Work Order ID 96340

Item ID: D206-642-541

Item Name: Replacement Skidtube

| DRAWING NO. D3274 | TITLE SKIDTUBE ASSEMBLY | REV. D | DART AEROSPACE USA, INC ENGINEERING ORDER | | D.E.O. NO. D3274-D-1 | SHEET NO. SHEET 1 OF 1 | SCALE NTS |

DETAIL F: END FINISHING DETAIL

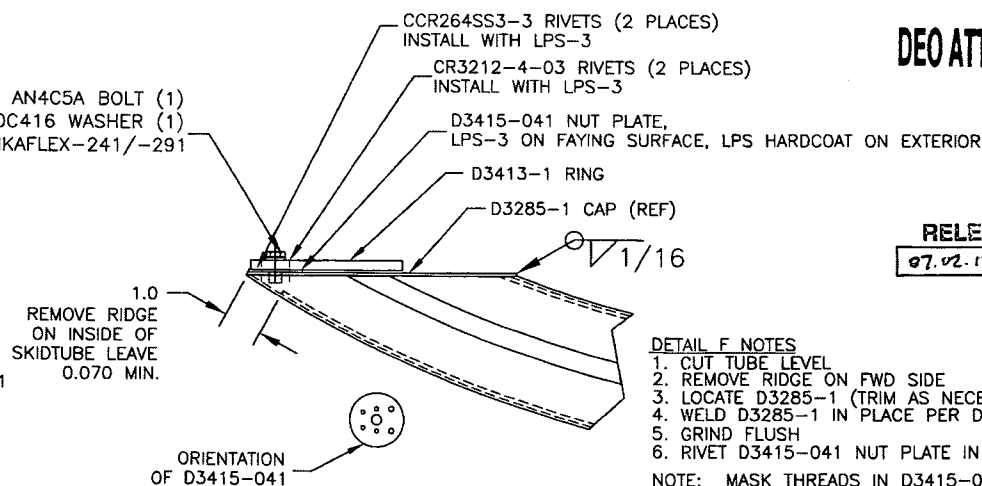
- DETAIL F NOTES
1. CUT TUBE LEVEL
 2. REMOVE RIDGE ON FWD SIDE
 3. LOCATE D3285-1 (TRIM AS NECESSARY)
 4. WELD D3285-1 IN PLACE PER DART QSI 004
 5. GRIND FLUSH
 6. RIVET D3415-041 NUT PLATE IN PLACE
- NOTE: MASK THREADS IN D3415-041
PRIOR TO FINISH

DETAIL F: END FINISHING DETAIL

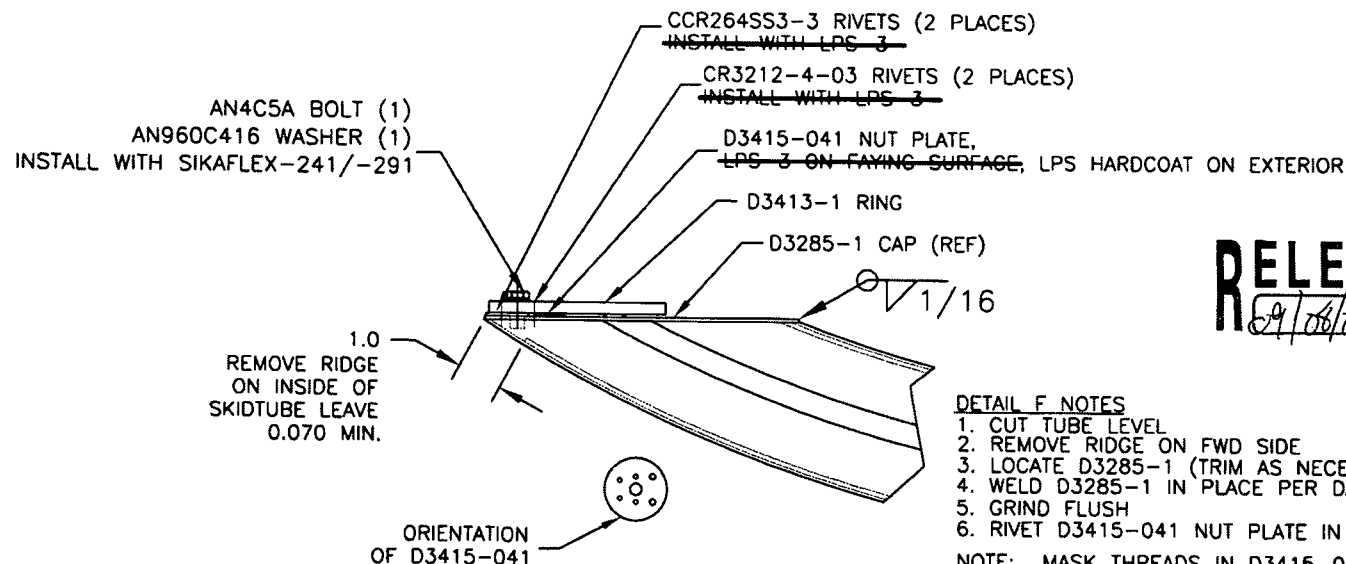
LPS-3 IS NO LONGER USED DURING ASSEMBLY OF SKIDTUBE.

AMEND DETAIL F AS SHOWN:

DETAIL F NOTES

1. CUT TUBE LEVEL
2. REMOVE RIDGE ON FWD SIDE
3. LOCATE D3285-1 (TRIM AS NECESSARY)
4. WELD D3285-1 IN PLACE PER DART QSI 004
5. GRIND FLUSH
6. RIVET D3415-041 NUT PLATE IN PLACE
